The difference of E173u-1 and E173u-6:

2. E173u-1 is the USB Stick which changed some components from E173u-6.

E173u-1 will get a new FCC ID: QISE173U-1.

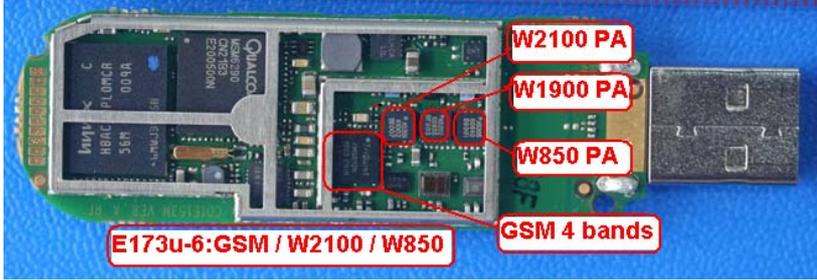
The differences between E173u-1 and E173u-6 are: E173u-1 removes the WCDMA1900 component and W850 component
